## **COMBS COURT SUBDIVISION**

APPLICATION NUMBER 9 DATE April 19, 2012  
APPLICANT Combs Court Subdivision  
REQUEST Subdivision

## DETAIL SITE PLAN

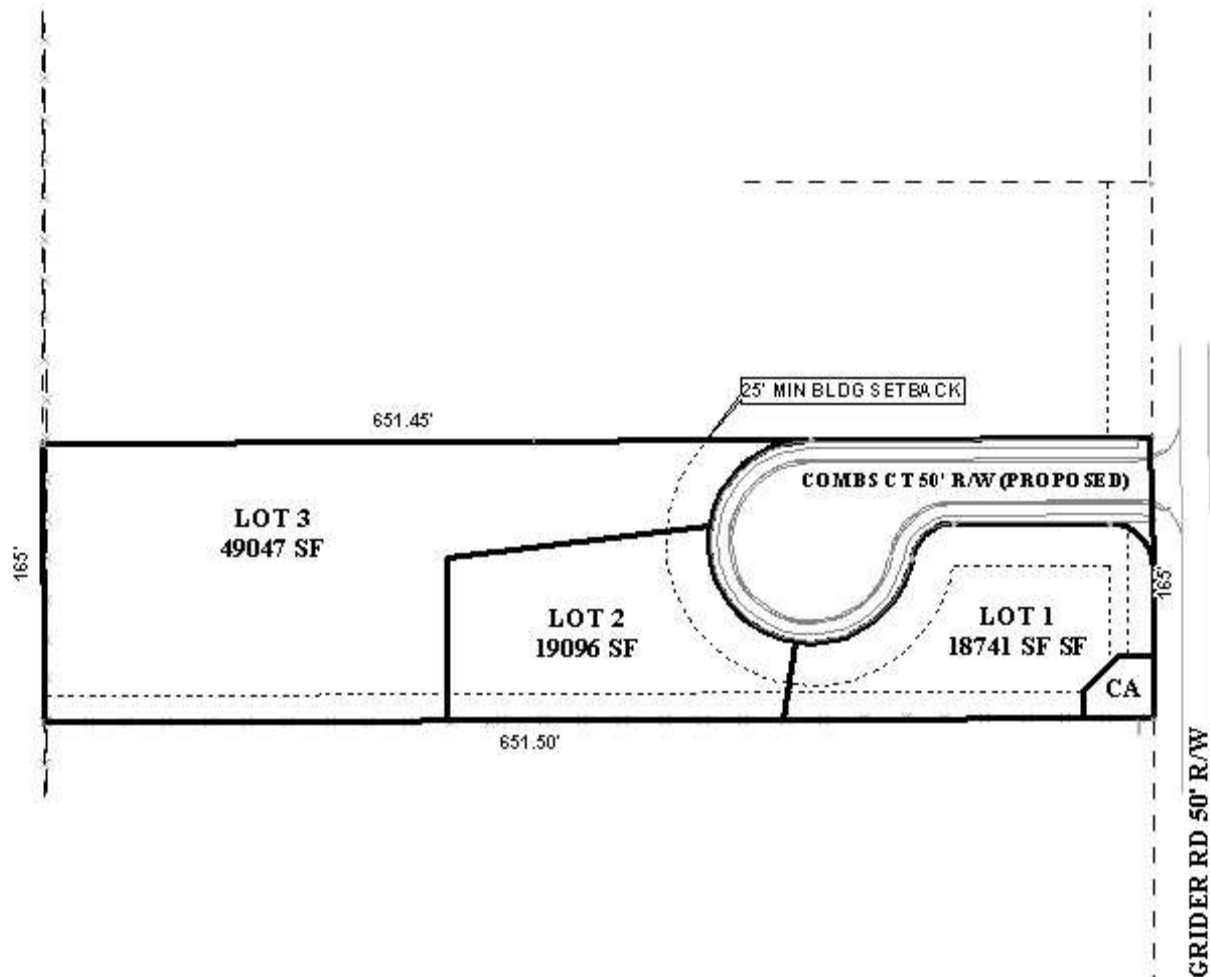
Traffic Engineering Comments: Proposed Combs Court must be constructed with proper corner turning radii on both corners of the new roadway, even though the radius in the north corner is not provided with the proposed right-of-way. Curb-cuts for Lots 1-3 should be limited to one each, with access only from Combs Court; size, location and design to be approved by Traffic Engineering and conform to AASHTO standards.

The purpose of this application is to create three legal lots of record from a single legal lot of record. The lot sizes are labeled, and the proposed lots would exceed the minimum size requirements of Section V.D.2. of the Subdivision Regulations. The lot sizes should be retained in square feet and acres on the Final Plat, if approved.

The 25-foot minimum building setback line, required in Section V.D.9., is illustrated and labeled along all existing and proposed rights-of-way on the preliminary plat, and should be retained on the Final Plat, if approved.

It should be noted that the proposed Lot 3 does not meet the standards for width-to-depth ratio. Section V.D.3. of the Subdivision Regulations states that lot depth should not exceed 3.5 times

the width of the lot at the building setback. As proposed, Lot 3 will be 84'± wide at the setback line and 450'± deep, resulting in a lot that is approximately 156' deeper than would normally be allowed. Because the existing lot, as well as several other lots in the area are shaped similarly, a waiver of Section V.D.3. of the Subdivision Regulations may be appropriate.

The site fronts Grider Road, a minor street lacking curb and gutter, with a right-of-way width of 50 feet. According to Section V.B.14. of the Subdivision Regulations, streets lacking curb and gutter should have a right-of-way width of 60 feet; however, since dedication was not required with the approval of Combs Place Subdivision in 2005 or the Combs Place Subdivision, Resubdivision of Lot 2 in 2010; it should not be a requirement for this application. The preliminary plat also illustrates a proposed new closed-end street, Combs Court, with a compliant right-of-way of 50 feet, and turnaround diameter of 120 feet. It should be noted that as per Traffic Engineering comments, Combs Court should have a compliant curb radii.

As a means of access management, a note should be placed on the Final Plat, if approved, stating that the lots are limited to one curb cut each to Combs Court, and Lot 1 should be denied direct access to Grider Road, with the size, location and design of all curb-cuts to be approved by Traffic Engineering and conform to AASHTO standards.

There is a common area shown on the preliminary plat. If approved, a note should be placed on the Final Plat stating that the maintenance of the common area is the responsibility of the property owners and not the City of Mobile.

Based upon the preceding, the application is recommended for Tentative Approval, with a waiver of Section V.D.3. of the Subdivision Regulations, subject to the following conditions:

- 1) provision of a compliant curb radii for Combs Court;
- 2) retention of the 25-foot minimum building setback line along all right-of-way frontages;
- 3) retention of the labeling of the lot with its size in square feet and acres, or placement of a table on the plat with the same information;

- 4) placement of a note on the Final Plat stating that the maintenance of the common area is the responsibility of the property owners and not the City of Mobile;
